RESPONSE TO REQUEST FOR ADDITIONAL INFORMATION

APR1400 Design Certification

RAI No.: 511-8668

SRP Section: 15.04.06 – Inadvertent Decrease in Boron Concentration in the Reactor Coolant (PWR)

Figure 1. Minimum DNBR vs. Reactivity Insertion Rate
(Bank CEA withdrawal transient at 102% Power)

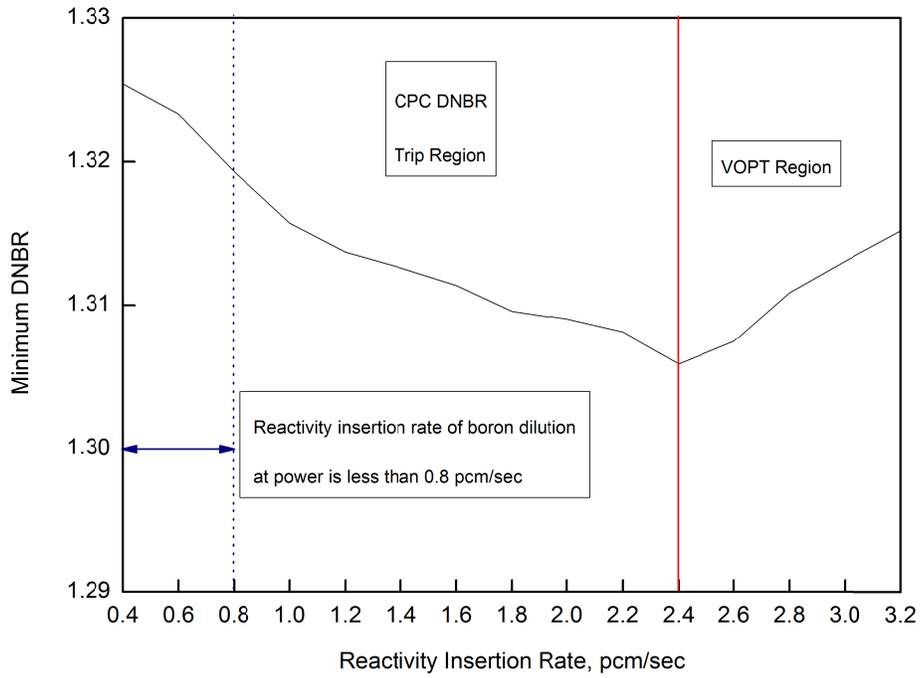
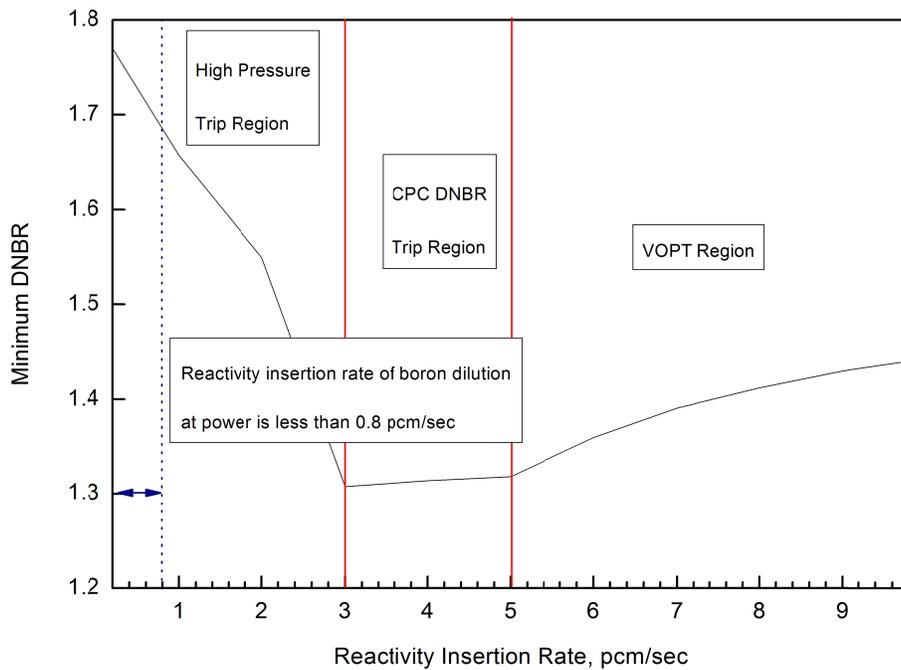
In response to RAI 8221, Question 15.4.6-5, the applicant stated that the reactivity insertion rate due to an at power boron dilution event is bounded by the control element assembly (CEA) withdrawal analyses of DCD Sections 15.4.1 and 15.4.2. The staff notes that the CEA withdrawal analyses do not violate the minimum DNBR limit as the variable overpower trip occurs limiting the power excursion. It is unclear to the staff that a slow reactivity insertion transient such as a boron dilution at power would be protected by the variable overpower trip. Therefore, please describe and update DCD section 15.4.6 with the reactor trip that would occur for an at power boron dilution event, and the technical basis why that reactor trip would prevent violating the minimum DNBR.

During a slow power increase transient such as a boron dilution at power, as the NRC staff noted in the question, the variable over power trip (VOPT) would not be appropriate to prevent the DNB violation. For this reason, APR1400 has a digital reactor trips: core protection calculation system (CPCS) DNBR trip or other CPCS auxiliary trip, such as cold leg temperature range trip and pressure range trip. The CPCS variable overpower trip can occur during fast power increasing transients and the CPCS DNBR trip or other CPCS auxiliary trip (cold leg temperature range trip or primary pressure range trip) can occur during slow power increasing transients. Figures 1 and 2, which were presented in RAI 8434, Question 15.04-02-1, show that the CPCS DNBR trip and other CPCS auxiliary trip can protect the DNBR limit for the slow reactivity increase transient and the VOPT can for the fast reactivity insertion rate case. The maximum reactivity insertion rate from an at power boron dilution event is less than 0.8 pcm/sec. Therefore the CPCS DNBR trip or the CPCS auxiliary trip can protect the DNBR limit for the boron dilution event at power and the minimum DNBR value is bounded by the control element assembly (CEA) rod withdrawal event.

The CPCS calculates a DNBR in the core not only the steady state but also the transient state. During transient situations, the inherent time response for the process instrumentation in the CPCS reactor protection system (RPS), and nuclear steam supply system (NSSS) to changes in the measured parameters will cause the inputs to the CPCS to lag, this is a condition that can actually exist in the plant. In some transient situations, this lag of CPC inputs could lead to the calculation of non-conservative values for DNBR. Therefore, CPC dynamic compensation algorithms exist to assure that during transient situations the CPCS will prevent the violation of the SAFDL on DNBR. This dynamic adjustment is accomplished by using static offset and digital filters to compensate for either the measured parameter directly (as is done for cold leg temperature and pressurizer pressure) or the calculated parameter (as is done for the thermal power, neutron flux power). The CPCS constants for the dynamic compensation algorithm and penalty values are determined at the final CPCS design stage for a constructed plant. The detailed technical basis for the dynamic CPCS DNBR compensation is presented in RAI 8434, Question 15.04.02-1.
